PRODUCT CHANGE NOTIFICATION (PCN)

AMJE0909-0050-BNB-24
MODULAR CABLE

CHANGE NOTIFICATION: PCN 20220509_AMJE0909-0050-BNB-24

DESCRIPTION OF CHANGES:
CHANGE OF DATA SHEET
CHANGE OF DATA SHEET
New Draw.-No. ASS_7945_CArev02

AMJE0909-0050-BNB-24 OLD VERSION

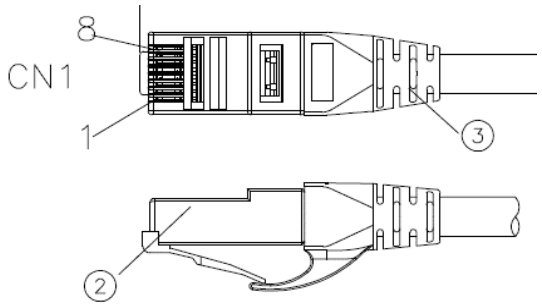
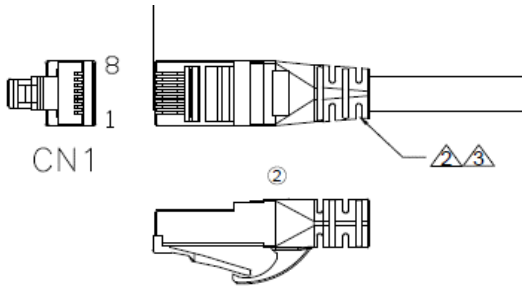
③	Molding	PVC 45P Color: see order code	NA	KG
②	CONNECTOR	RJ45 8P8C two fork Short type 3u" gold plated	2	PCS
①	CABLE	CAT6 UTP (24AWG*1PR)*4+PVC OD=5.8±0.3MM Color: see order code	NA	MM
NO:	NAME	DESCRIPTION	Q'TY	UNIT

3	Molding	PVC 65P Color: see order code ②	NA	KG
2	CONNECTOR	RJ45 8P8C PLUG 3u" gold plated ②	2	PCS
1	CABLE	CAT6 U/UTP (24AWG*1PR)*4+Cross+PVC Jacket OD=5.8± 0.3MM Color: see order code ②	NA	MM
NO:	NAME	DESCRIPTION	Q'TY	UNIT

Drawing-No.
ASS 7945 CA

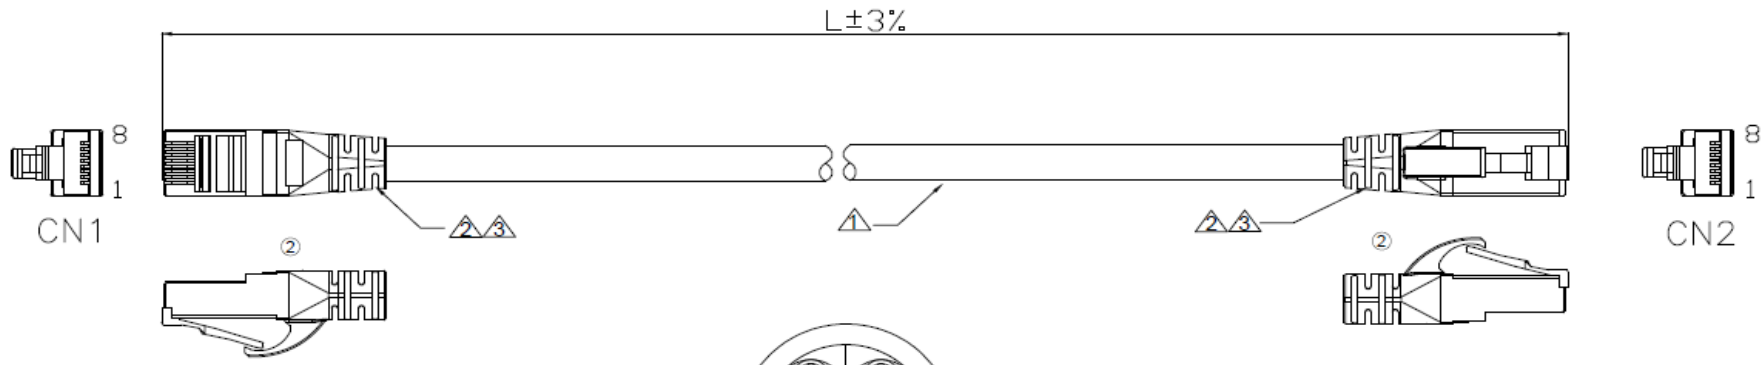
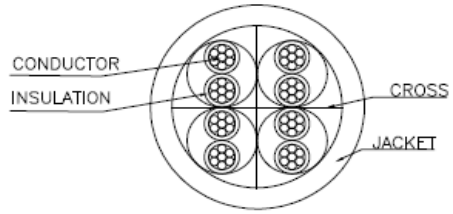
Id.	Modification	Date	Name
②	Change the plant	09.05.2022	Luca
①	Update the WSW order code	02.06.2017	Amy
⓪	Drawn	30.03.2017	Amy

NO:	NAME	DESCRIPTION	Q'TY	UNIT
3	Molding	PVC 65P Color: see order code ②	NA	KG
2	CONNECTOR	RJ45 8P8C PLUG 3u" gold plated ②	2	PCS
1	CABLE	CAT6 U/UTP (24AWG*1PR)*4+Cross+PVC Jacket OD=5.8± 0.3MM Color: see order code ②	NA	MM
